Project 421 Public Hearing Comments

Date of Hearing: February 20, 2018

Public Hearing Meeting Minutes

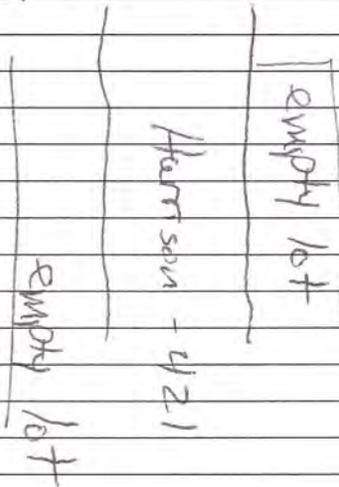
① On entering Madison from KY, there are 3 empty parking lots that have 2 flea markets (one on each side of street). What happens to them? They are an eye sore.

② What happens to the gas station?

As a result of a formal comment submitted at the public hearing for this project, below is a response to a comment regarding how some parcels adjacent to the project will be affected. The individual specifically asked what would happen to the liquor store and the three empty parking lots.

In order to provide a direct route that maximizes mobility and safety while also minimizing impacts to environmental and cultural resources, the liquor store and the lot in the southeast corner of the 2nd Street/Harrison Street intersection will both be acquired. Some right of way acquisition is needed from the lot in the southwest corner of the 2nd Street/Harrison Street intersection, but the portion to be acquired is limited to that which is necessary to construct the project. The other lot on the west side of US 421 will not be impacted by the project.

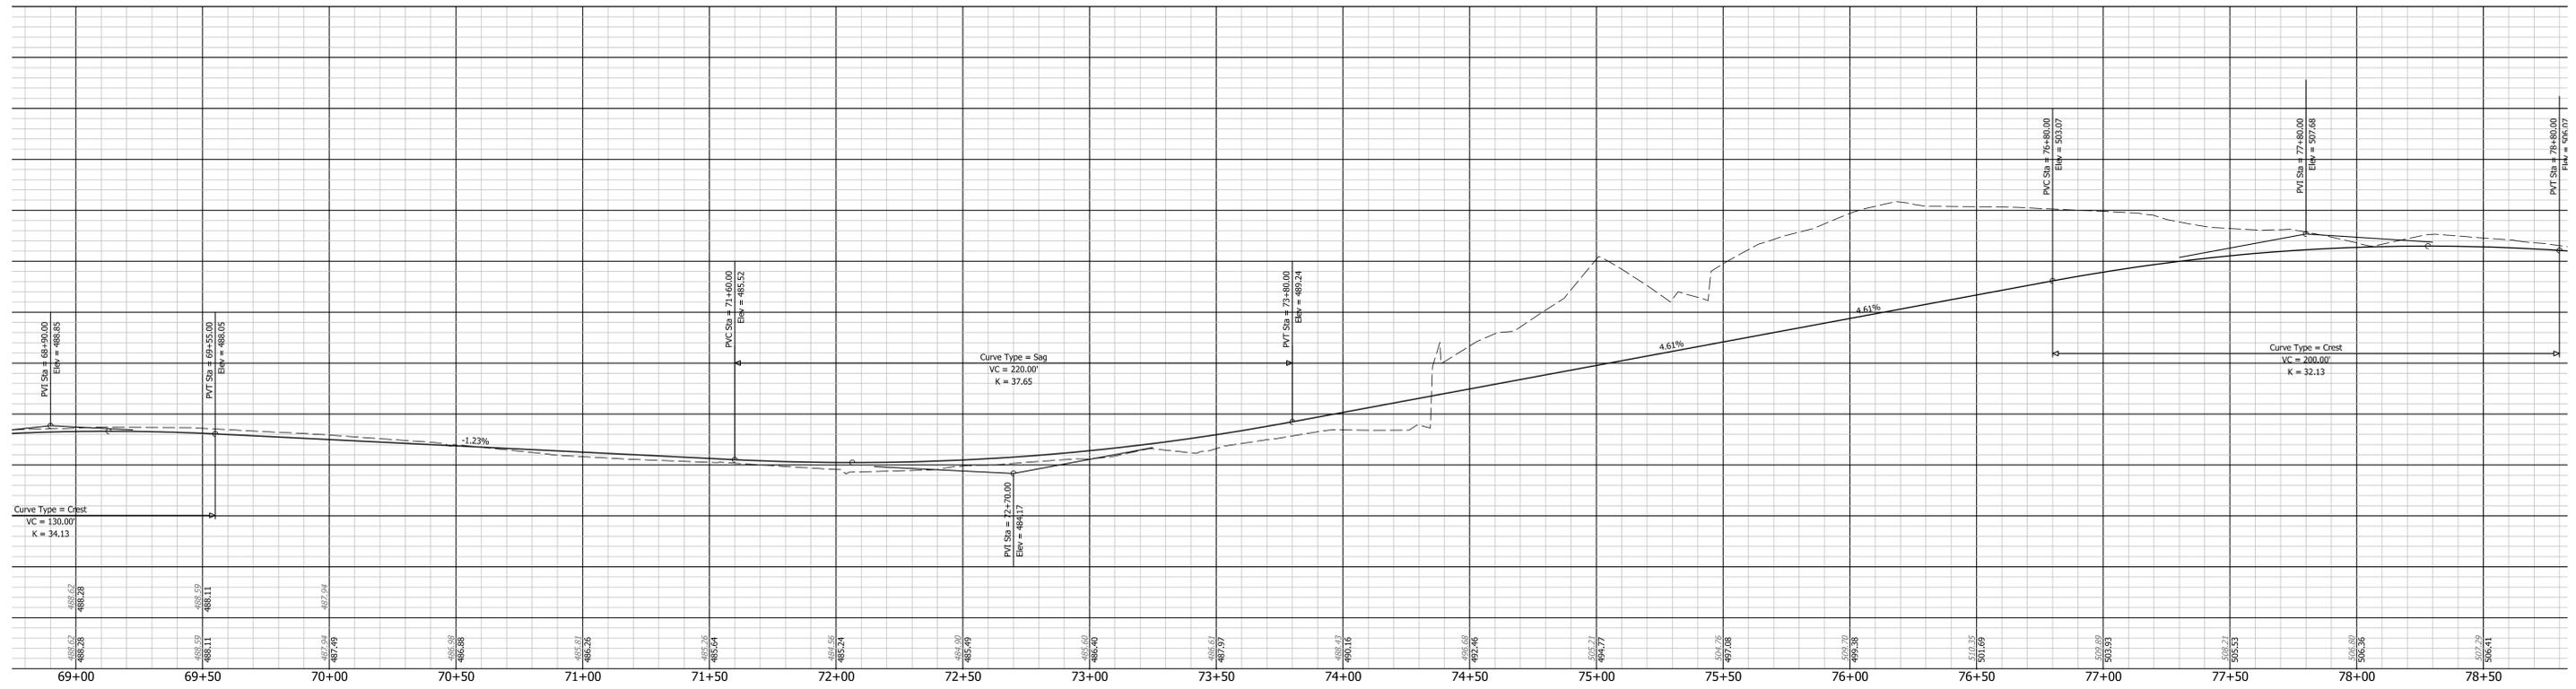
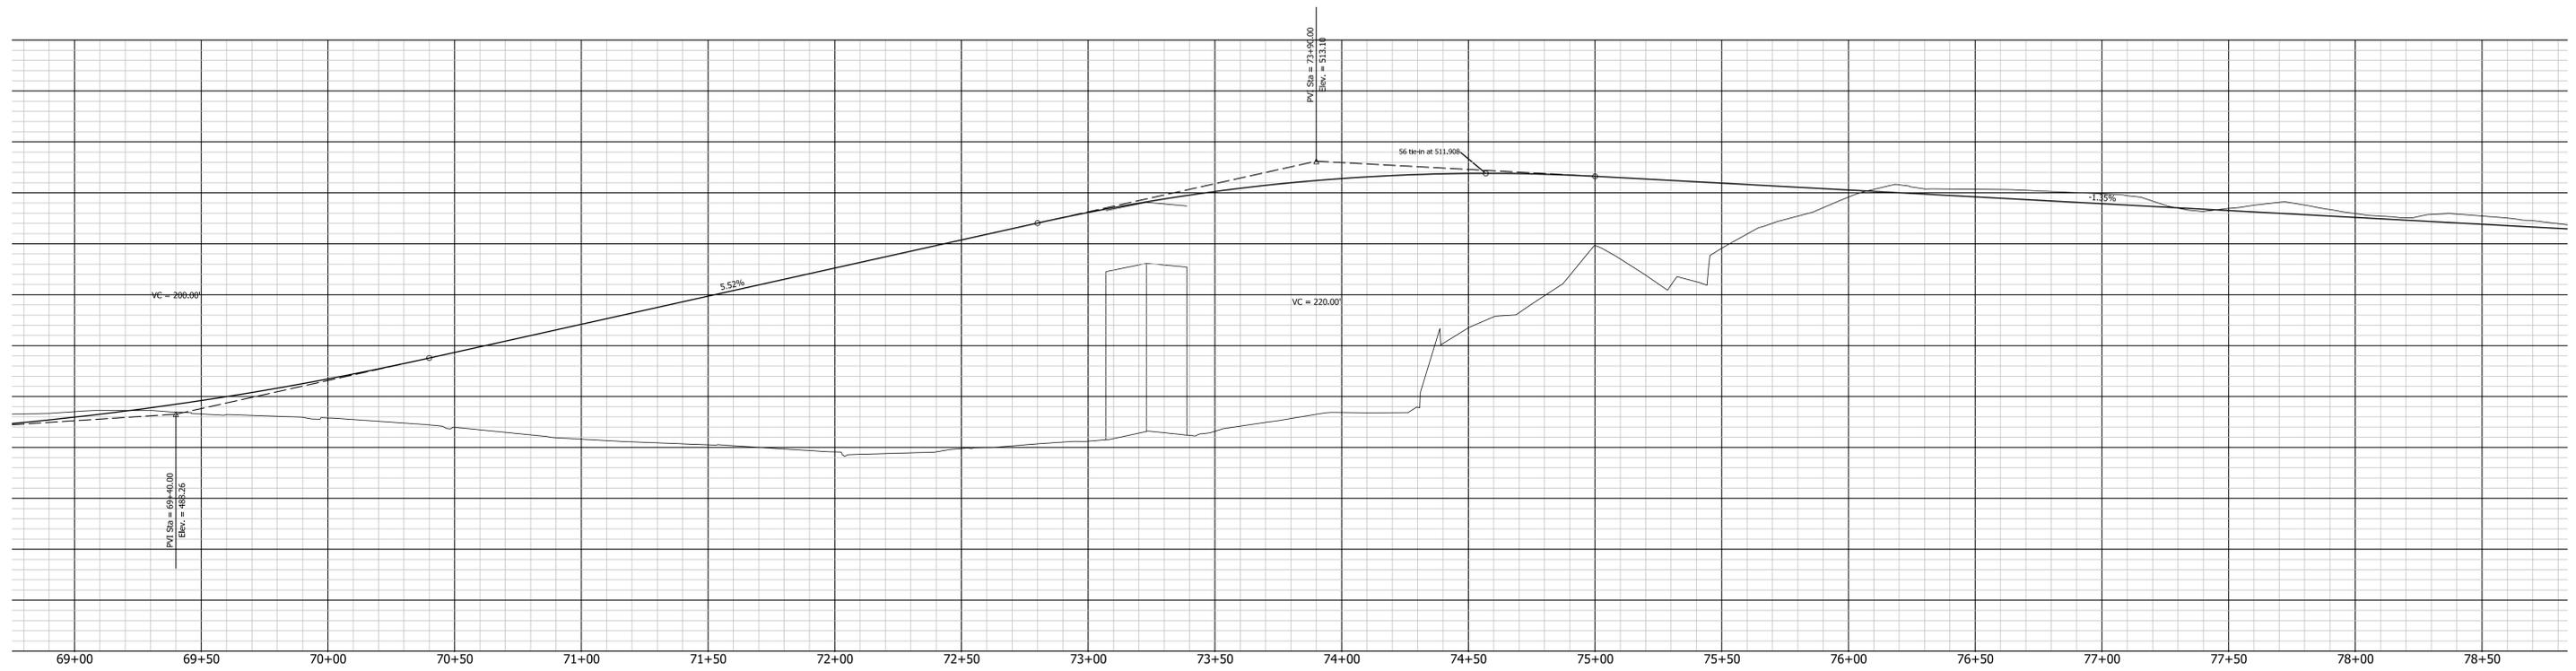
I have large concern about the new 4.5% grade ~~commen~~ starting at 2nd Street + continuing up to Main Street.

Trucks will stop at the new light at 2nd Street then have to negotiate the steep 4.5% grade from a full stop. Very bad, very slow

The current proposed grade of US 421 between 2nd Street and Main Street reaches a maximum of 4.61%. This grade is needed to make up an approximately 24-foot change in elevation from 2nd Street to Main Street. Northbound traffic, if stopped, would be stopped on a 2.0% or less grade, which is a common intersection approach slope.

Maximum grades for other alternatives are similar to or greater than the preferred alternative, which would increase noise and emissions from trucks. Other alternatives may require traffic to stop on a similar grade. A profile from another alternative is provided as a reference to which to compare the profile for the preferred alternative.

In conclusion, the preferred alternative provides improved mobility and safety, as well as a more gradual grade, compared to other alternatives. Other alternatives require vehicles to stop on a similar grade at the intersection and may require vehicles to come to a complete stop prior to going up the maximum roadway grade. Therefore, it is recommended that the current preferred alternative design be retained to minimize noise impacts due to a lesser grade and providing improved mobility and safety.
